DEVELOPMENT CONSENT AUTHORITY
DARWIN DIVISION

AGENDA ITEM: **1** MEETING DATE: 6/12/2024 FILE: PA2024/0126

APPLICATION: Addition (storage rooms with ablutions) to an existing dwelling-multiple with a reduced building setback to the rear boundary
APPLICANT/CONTACT: Goldbox (Maria Pajarillo)
LAND OWNER: K Food Land Pty Ltd
BENEFICIARY: Landowner
LOCATION: Lot 6079 (23) Kelsey Cres, Millner Town of Nightcliff (**Bookmark A**)
ZONE: MR (Medium Density)
AREA: 791 m²

Figure 1: Extract from site plan showing proposed storage rooms at the rear of the site

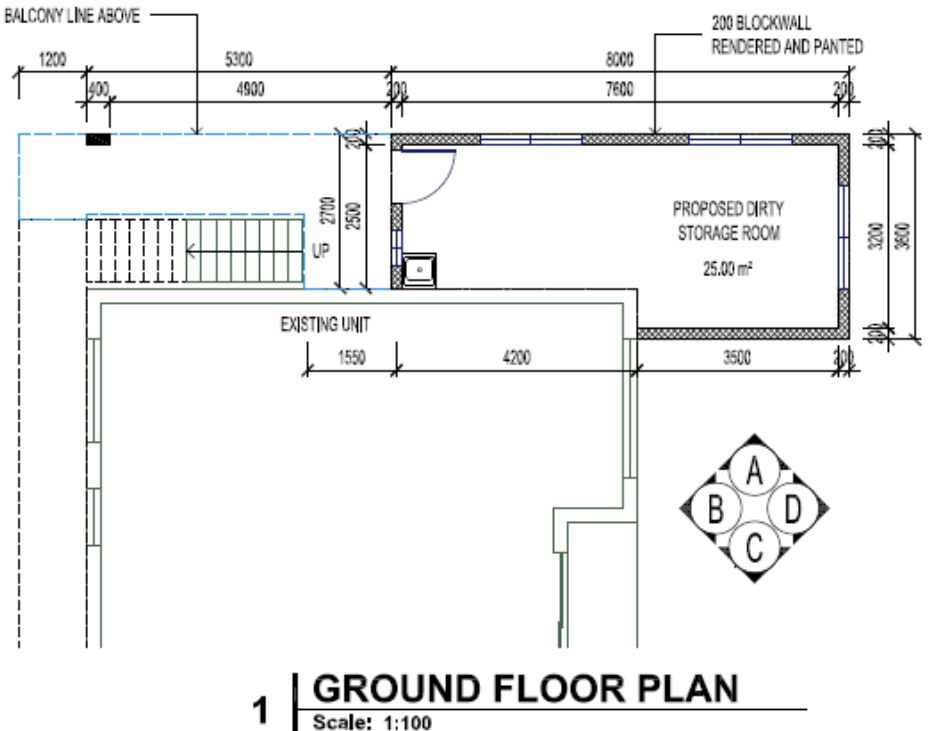
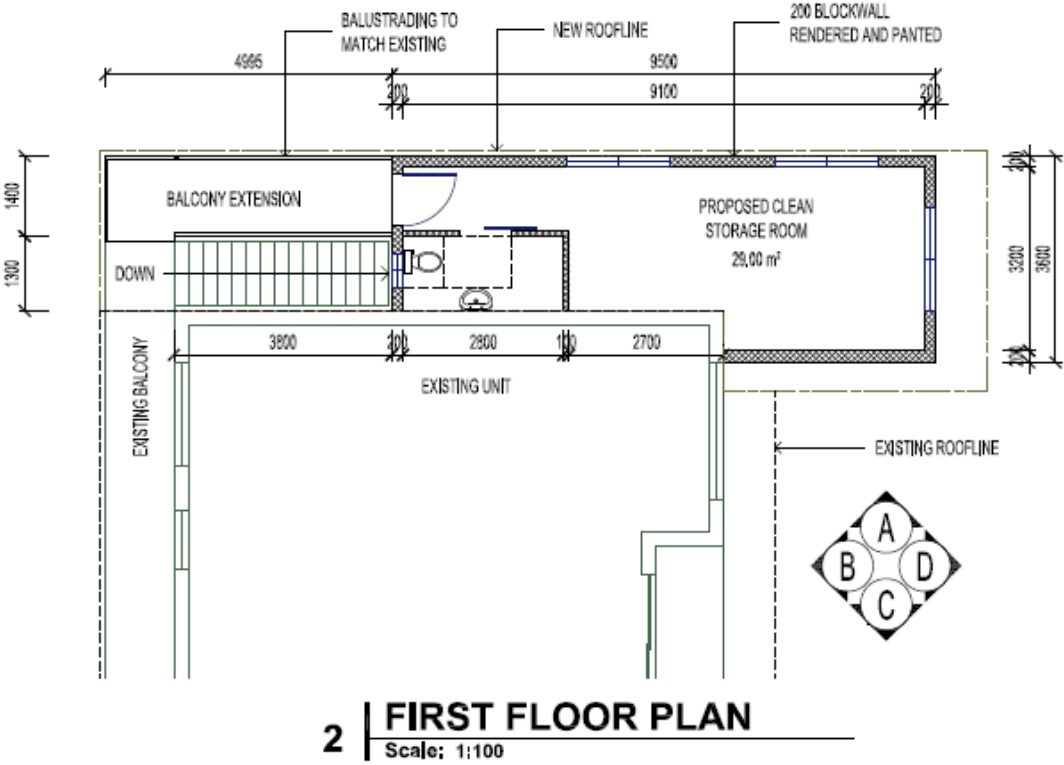
This amended application is still for 2 x storage room additions to an existing dwelling-multiple. The additions are located at the rear of the lot, however, are proposed in a two storey arrangement, which results in a singular non-compliance with the rear boundary setback. The development takes the form of an extension to the existing dwelling-multiple building, however does not propose any changes to the car parking arrangements or access, nor other aspects under the NT Planning Scheme 2020.

The proposed storage room additions are seeking a variation (to sub-clause 6(a)) of 1.5 m building setback, 1.4 m roofline setback to the rear boundary, and 2.8 m setback to the western property boundary, where the NTPS 2020 requires a 3 m building setback and 2.1 m roofline setback for ancillary structures in Zone MR to the side and rear boundaries.

1 | SITE PLAN

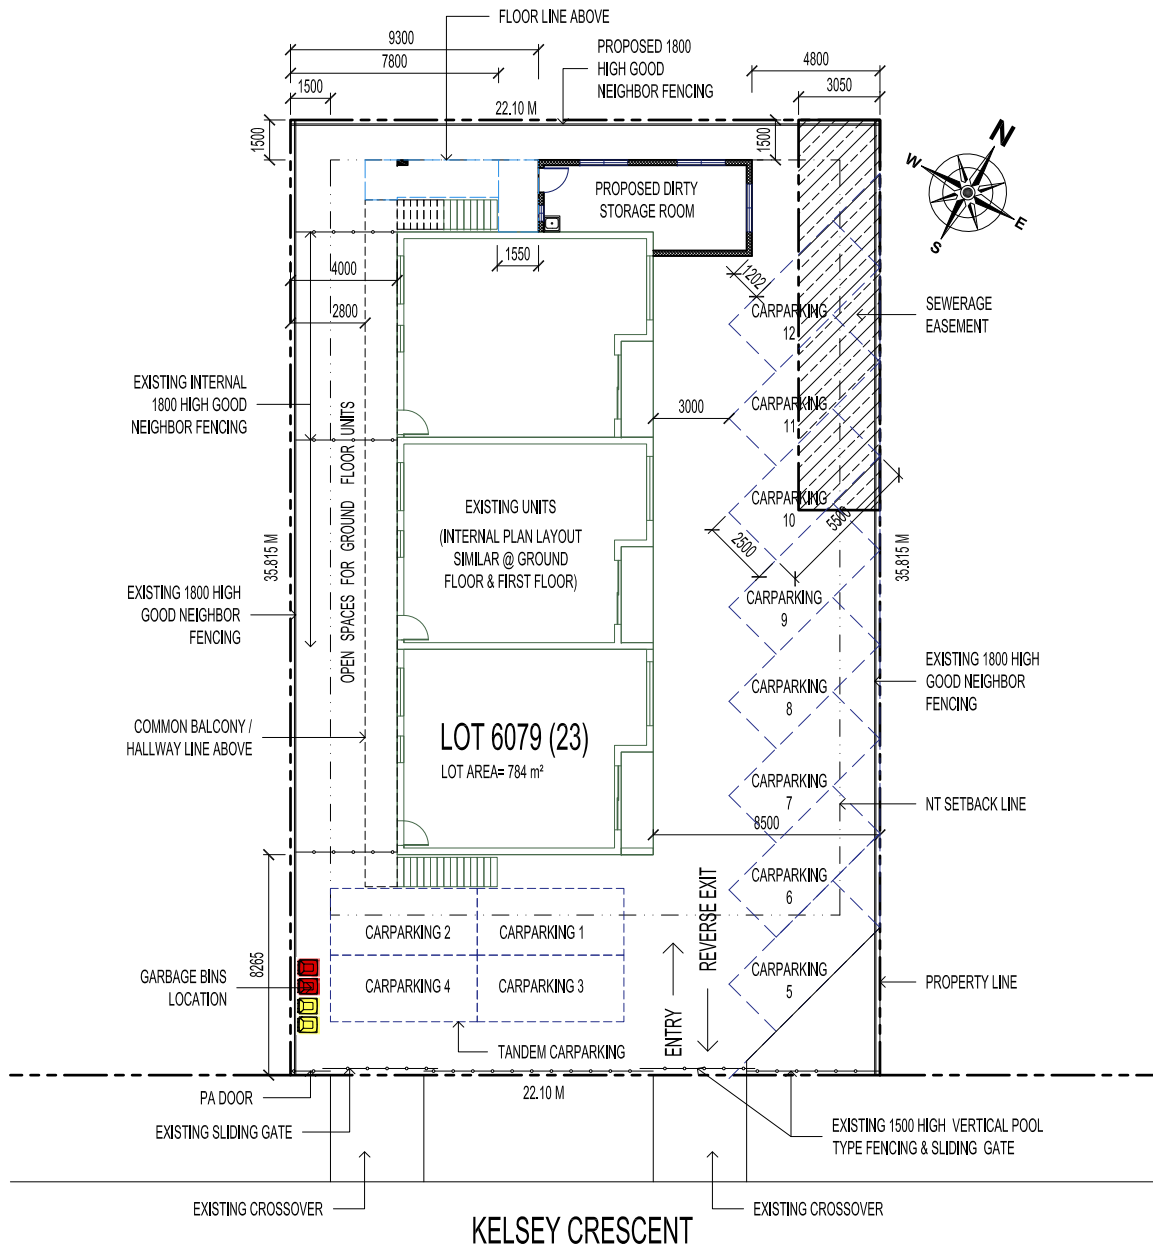
The proposed storage rooms would no longer result in adverse building massing when viewed from adjoining land the street since the proposed setbacks are less than previously proposed. The rear setback is no longer a firewall but is designed to continue the existing building form. The storage rooms are aligned vertically therefore a lot shorter from previous proposed width. Wall treatments such as similar rendering and finish with feature tile wall will also be provided to provide a positive visual impact to surrounding properties.

The proposed windows are above 1.6 meter high therefore minimising overlooking of adjoining properties. These were provided for some ventilation and natural lightning during daytime. The windows act as additional wall treatments as well.

As previously noted, the proposed amended plans now have appropriate side setbacks and 1.5-meter rear setback therefore not requiring massive firewalls. The proposed storage rooms in terms of width no longer covers the majority of the rear site providing enough breeze penetration.
